KITTERY TOWN PLANNING BOARD MEETING
Council Chambers – Kittery Town Hall 200 Rogers Road, Kittery, Maine 03904
Phone: 207-475-1323 - Fax: 207-439-6806 - www.kittery.org

AGENDA for Thursday, April 10, 2014
6:00 P.M. to 10:00 P.M.

**RE: Town of Kittery, Planning Board Services
Estes Propane Storage (Tax Map 67, Lot 4) Review #3
CMA #591.77**

Estes Bulk Propane Storage – Public Hearing / Preliminary Plan Review.

SCALE: 1" = 40'	APPROVED BY:	DRAWN BY: JLC
DATE: 11/7/13		REVISION : DATE C : 3/19/14
JOB NO: C082-13	CAD FILE: ESTES PROPANE BASE	SHEET 2

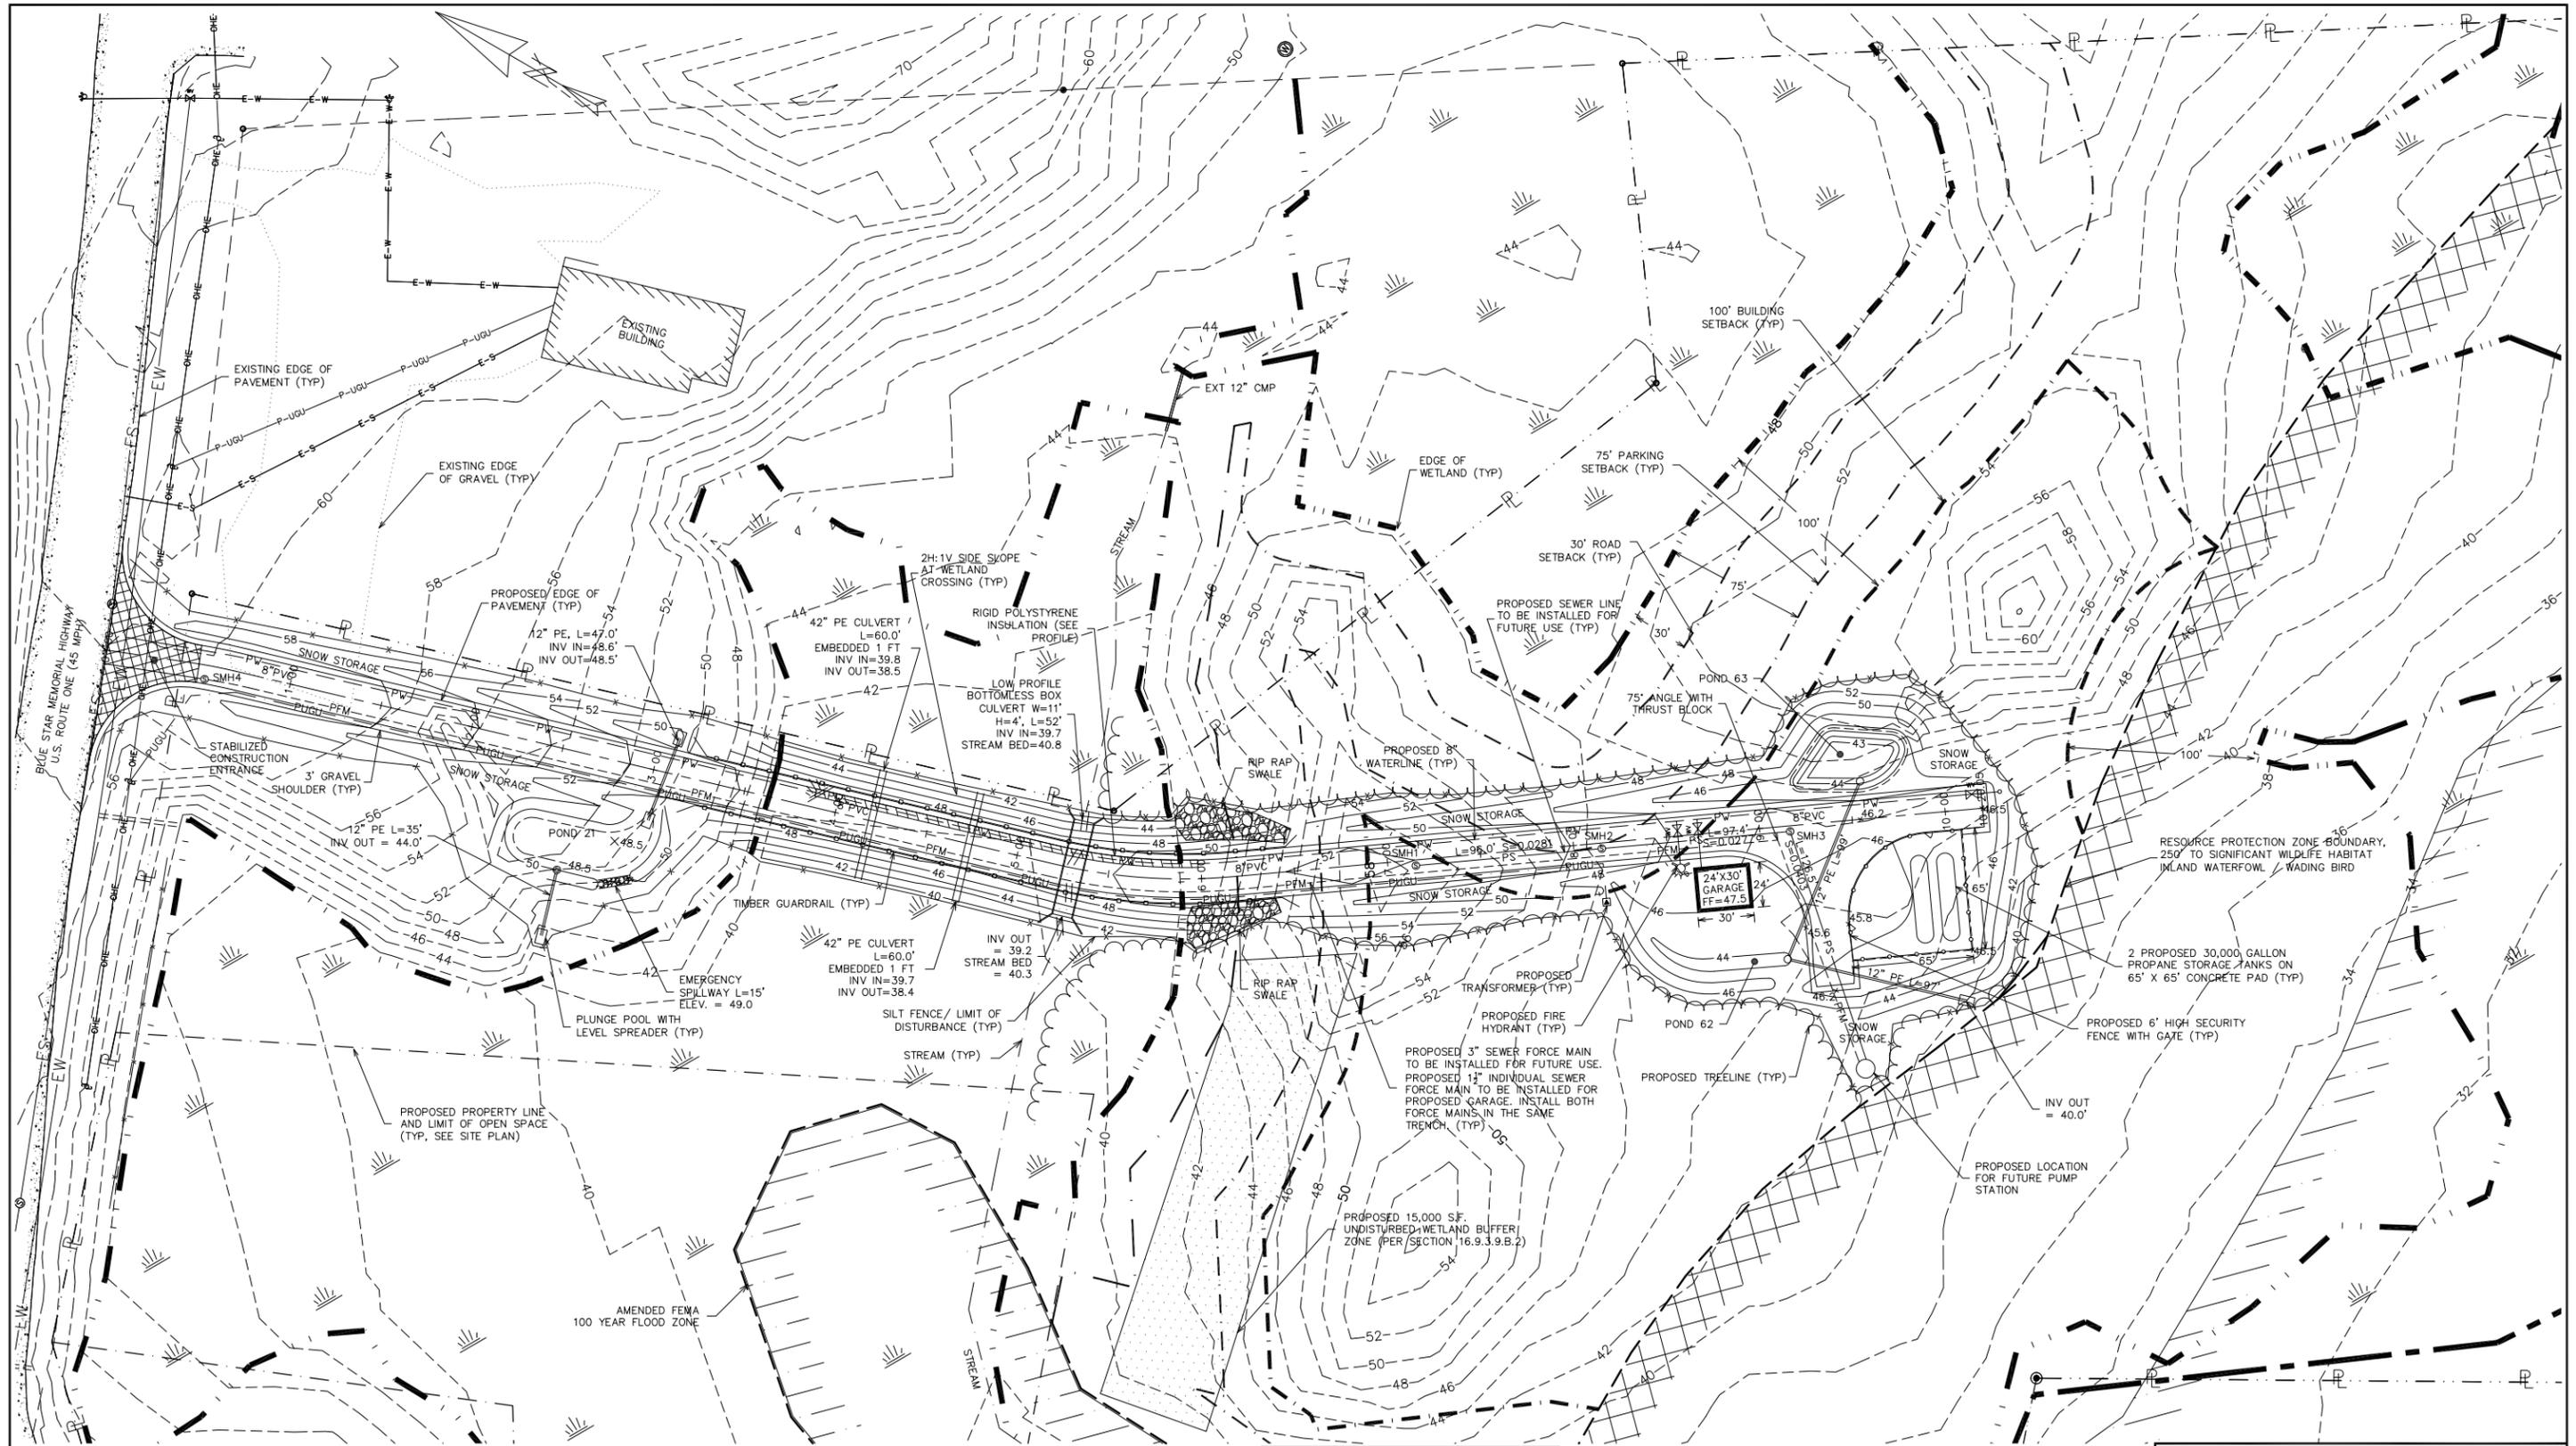
The Applicant has shown the location of a gravity sewer and a sewer force main on site for future use. The gravity sewer main includes three sewer manholes and seems excessive for sewer use associated with an equipment storage garage. Please clarify.

16.8.9.4.D. There is no parking indicated for the warehouse. Is that intended to be at the "hammer head"? If so, does that parking impede trucks? Please clarify.

- b) Snow storage areas have been added to the Grading Plan (sheet 2).
 - c) While this is the first propane storage facility in the town of Kittery, the Special Exception definition states that Special Exception Use is "controlled as to number, area, location, or relation to the neighborhood" and therefore, does not result in propane storage becoming an approved or typical use in the zone.

The water line, sewer line and underground utilities have been updated on the Grading Plan. The water line, sewer lines, and sewer force main have been added to the Plan & Profile (sheet 3). A Stormwater Management Plan has also been prepared and is enclosed.

SCALE: AS NOTED	APPROVED BY:	DRAWN BY: JLC
DATE: 11/7/13		REVISION : DATE A : 3/19/14
JOB NO: C082-13	CAD FILE: ESTES PROPANE DTL	SHEET 5

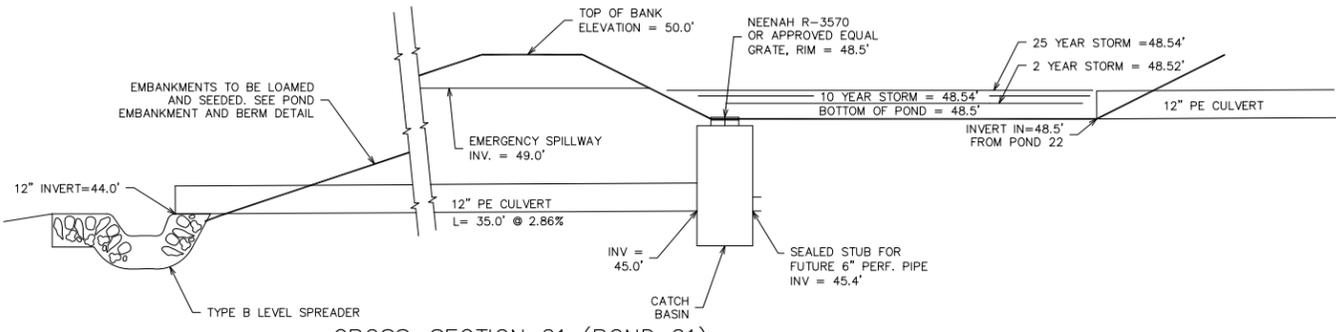
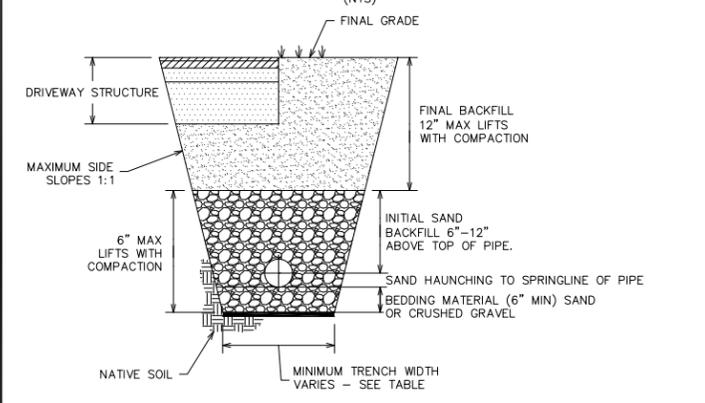
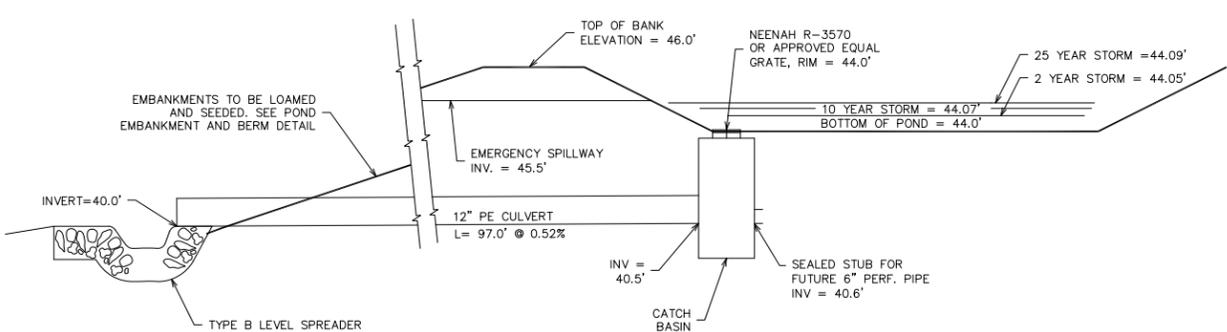
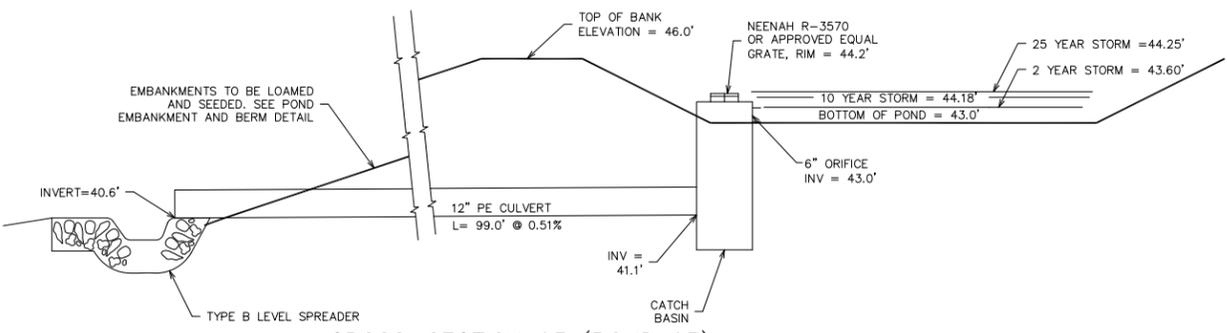
1. What is the purpose of the "sealed stub for future 6" perforated pipe" in the catch basins at ponds 21 and 62 (Sheet 5)?
2. The Existing Drainage Diagram in the Stormwater Management Plan erroneously reference reach "2R". We believe this should be "1R".
